NORTH AMERICAN - MODIFICATION OF LANDING GEAR WARNING AND INDICATING SYSTEM - P-51D, TP-51D AND F-6D

Figure 1

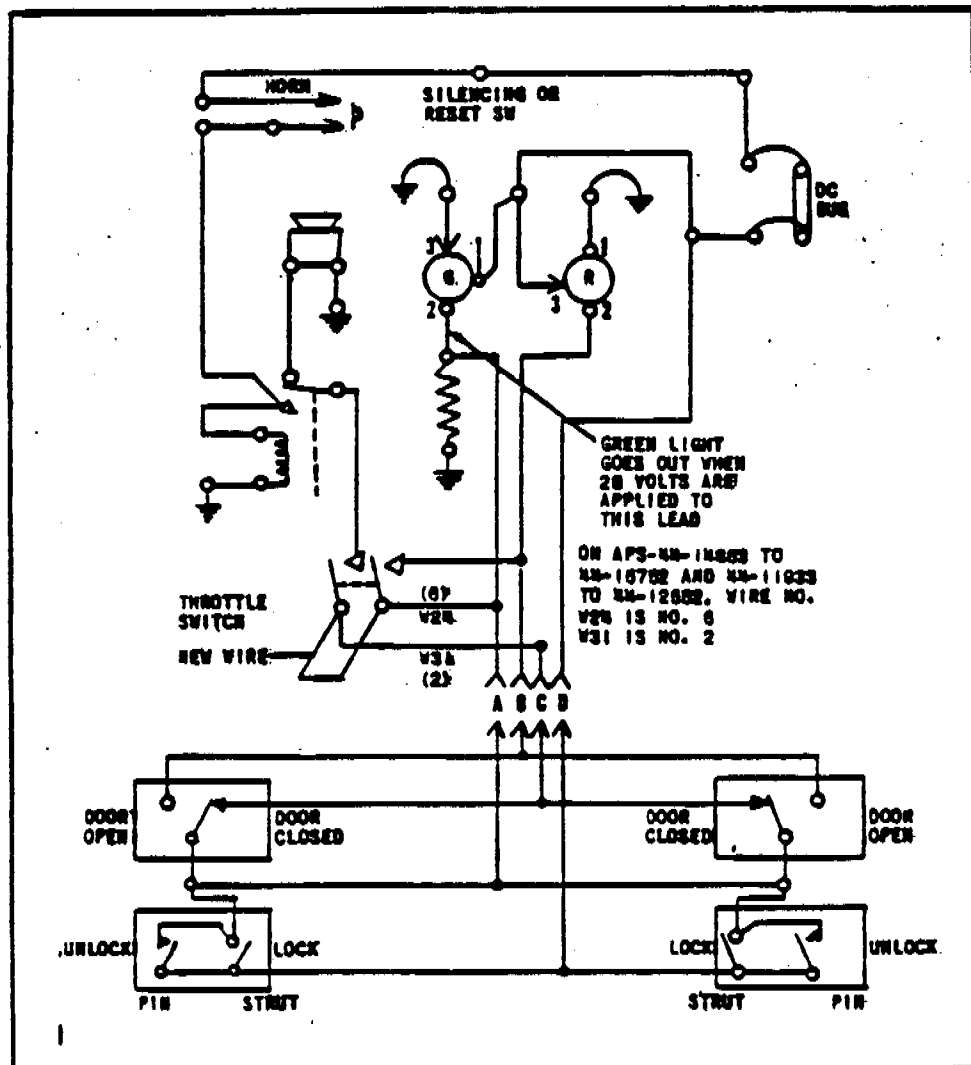
1. To provide for operation of the landing-gear warning horn at any time that the throttle is retarded, and the landing gear is in any position except "DOWN"

3. Fabricate a jumper wire approximately 4 inches long of No. 18 aircraft low-tension cable. Attach a terminal lug to each end of the wire and connect the wire between wires Nos. W31 and W24 at the throttle switch. (See figure 1.) This switch may be found slightly below and forward of the throttle quadrant, on the left side of the cockpit.

(1) With wheels "DOWN" and "LOCKED," green light will be on and horn will not sound regardless of throttle position.

(2) With wheels in an intermediate position but not locked, red light will be on. Horn will blow if throttle is retarded.

(3) With wheels "UP" and "LOCKED" and fairing doors closed, horn will not sound and red light will be out if throttle is forward. Retard throttle and red light will come on; horn will sound.

(4) Horn can be silenced by momentarily operating silencing switch. Horn silencing feature will release when throttle is advanced. Refer to figure 1 for wiring diagram.
